Rear Bumper Outer End Covers Loose Causing Excessive Gap

Service Category Vehicle Exterior

YEAR(S)	MODEL(S)	ADDITIONAL INFORMATION
2022 - 2024	Tundra, Tundra HV

Figure 1. Example of Condition on Right-hand Side

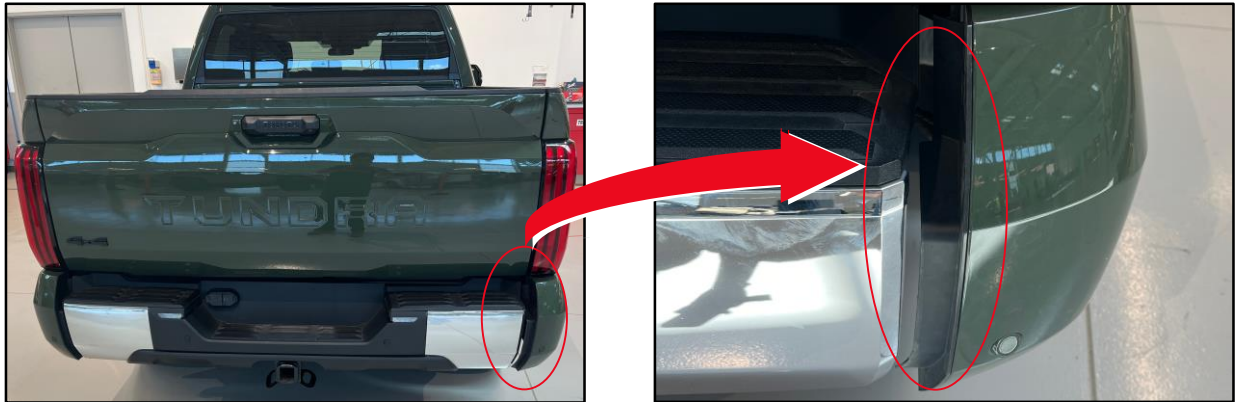
Does the vehicle exhibit a condition in which the rear bumper outer end covers have become loose causing an excessive gap on the right-hand and/or the left-hand side as shown in Figure 1?

Figure 3. Rear Pillar Lower Garnish, Not Properly Retained at Attachment Points

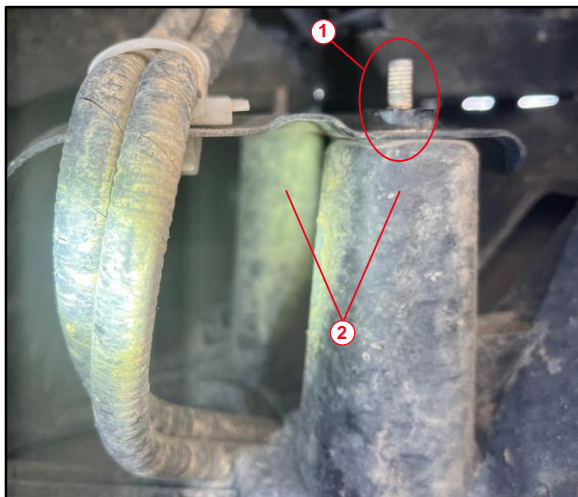
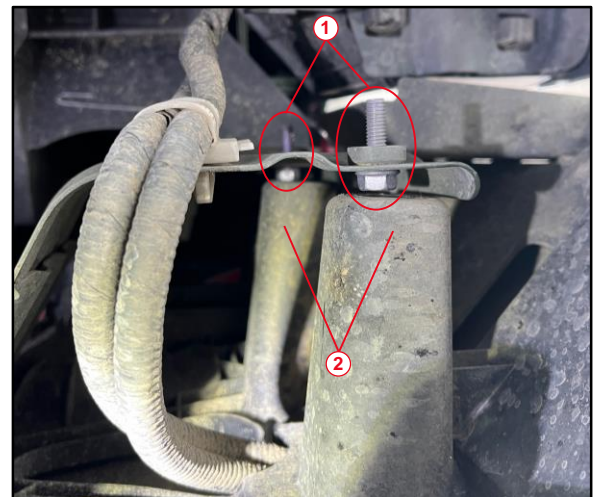
2. Raise the vehicle on a lift and from under the vehicle, inspect the rear pillar lower garnish attachment points for proper retention.

Bolt heads should NOT be visible if the rear pillar lower garnish attachment points are properly retained.

- Install the NEW rear pillar lower garnish using NEW flange bolts.
